III. CORRECTIONS AND ADDITIONS

The following corrections and additions to the Canyon Hills Project Draft Environmental Impact Report (the “Draft EIR”) have resulted from the Lead Agency’s review of the comments received during the 90-day public review period. Changes to the Draft EIR are listed by the corresponding Draft EIR Section, subsection, if applicable, and then page number.

Figure IV.B-2
1998 Model Estimated Risk for the Basin (all sources)

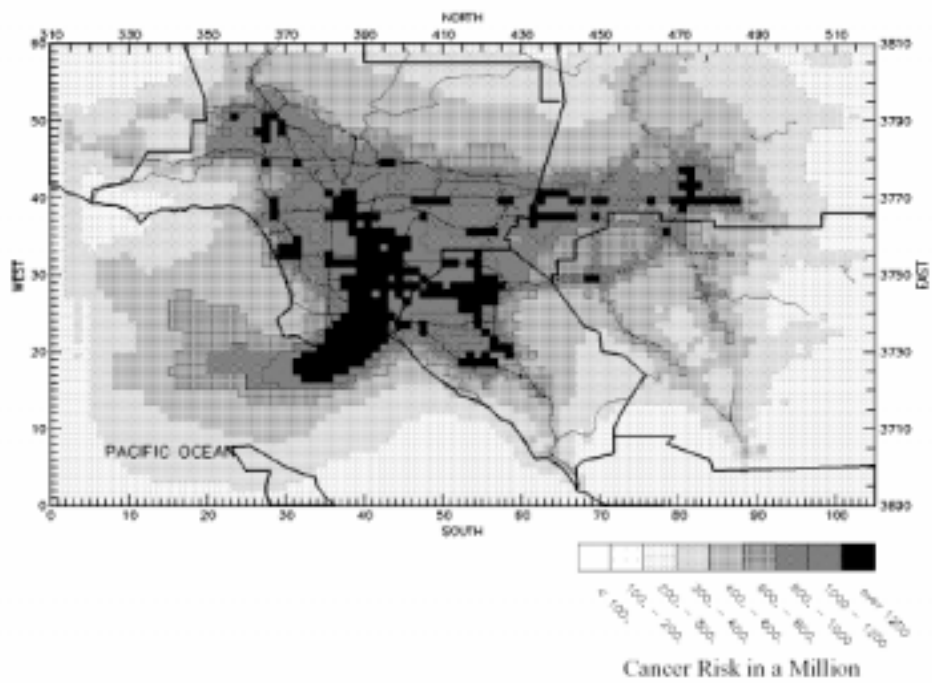
The following text has been added after Table IV.B-7 and before the “Mitigation Measures”:
